Ms Aisling Connolly,  
Environmental Licensing Programme,  
Office of Environmental Sustainability,  
Environmental Protection Agency,  
Headquarters PO Box 3000,  
Johnstown Castle Estate.  
County Wexford.

Re: Application for Licence Reg No: W0291-02

I refer the Agency's letter dated 29<sup>th</sup> August in accordance with Regulation 10(2)(b)(ii) of the EPA (Industrial Emissions) (Licensing) Regulations 2013 in respect of a licence application from Forge Hill Recycling Unlimited Company for an installation located at Forge Hill, Cork, T12 AK44. The requested information is set out herein. The EPA's requests are set out in italics followed by the response.

Project: FORGE HILL RECYCLING LTD  
 Client: FORGE HILL RECYCLING LTD  
 Drawing Title: WASTE STORAGE PLAN  
 Scale: 1:250 @A1  
 Date: Sept. 2019  
 Drawn By: G. Forde  
 Checked/Issued: G. Forde  
 4348-WI-08

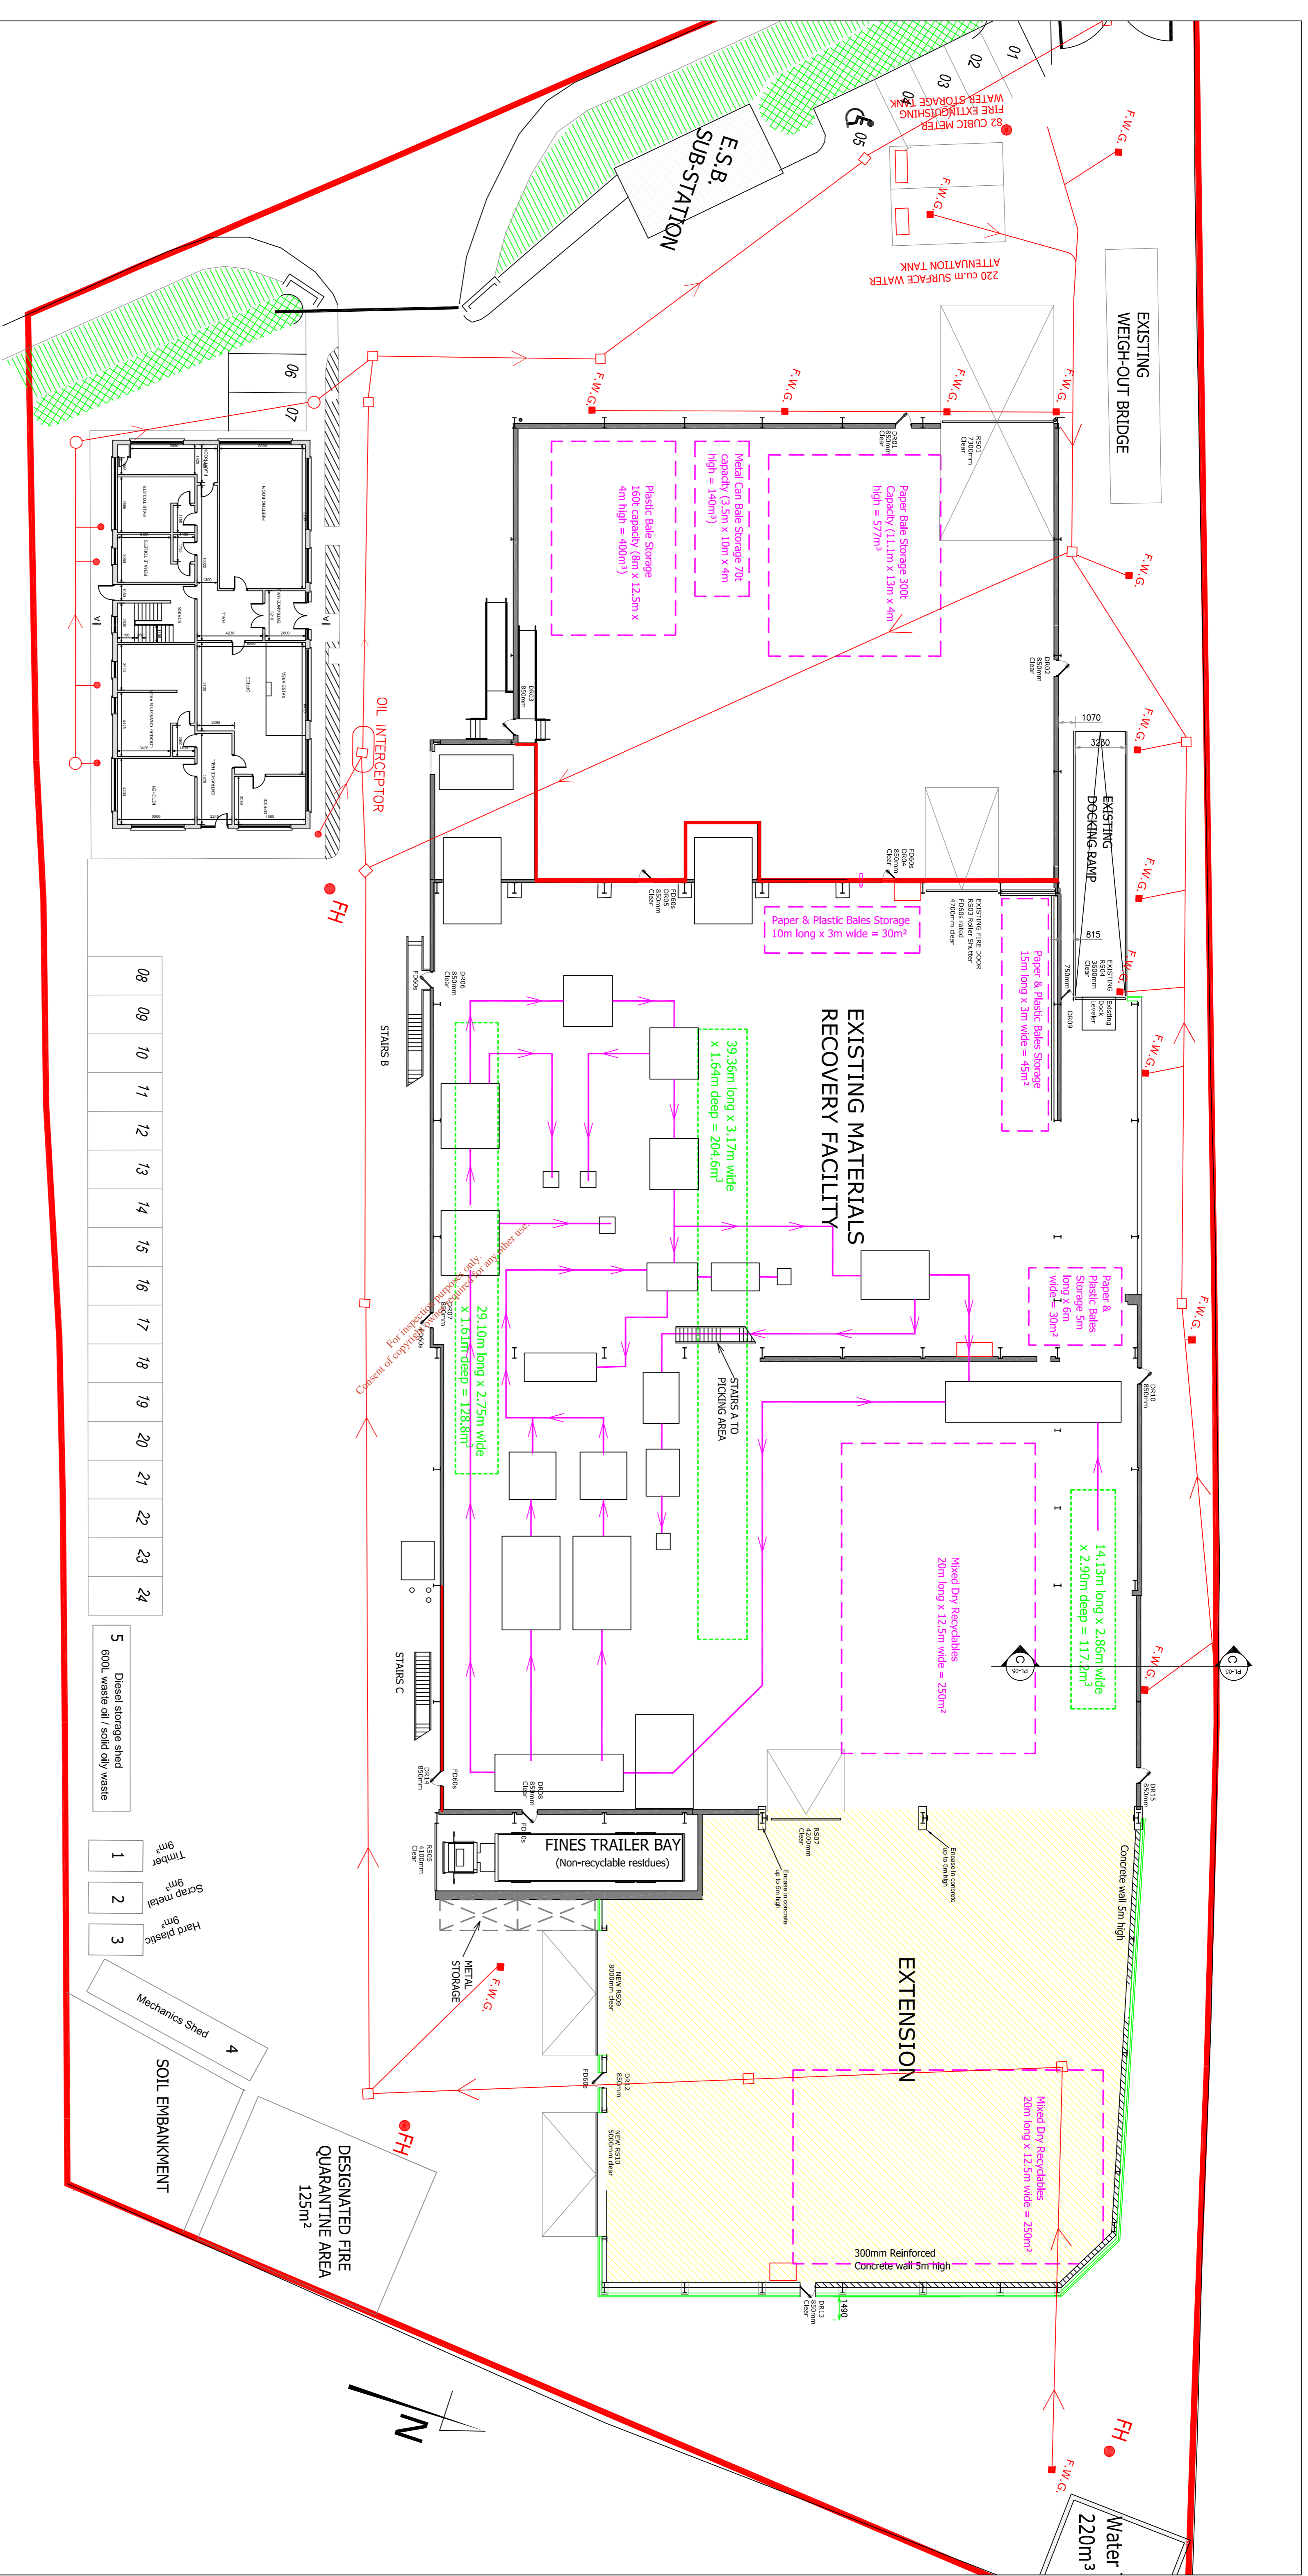
3. In relation to the fully enclosed trailer which is proposed to store non-recyclable residues externally, clarify the following:
- Is the trailer designed to prevent leachate from the materials contained within.
  - What is the nature of the underlying surface where the trailer is stored and is the surface impermeable, and;
  - Provide an updated Waste Storage Plan Map (Drawing No. 14/4347-PL-04) showing the location of the trailer.

The trailer is indoors and fully enclosed. It is used to store predominantly dry material fines, such as small grade paper and plastic. The trailer is designed to prevent leachate from the materials contained within it. The building where the trailer is parked has a paved impermeable floor. An updated Waste Storage Plan (Drawing No. 4348-WL-08) showing the location of the trailer is in Attachment 2 and supersedes Drawing No. 4348-WL-04).
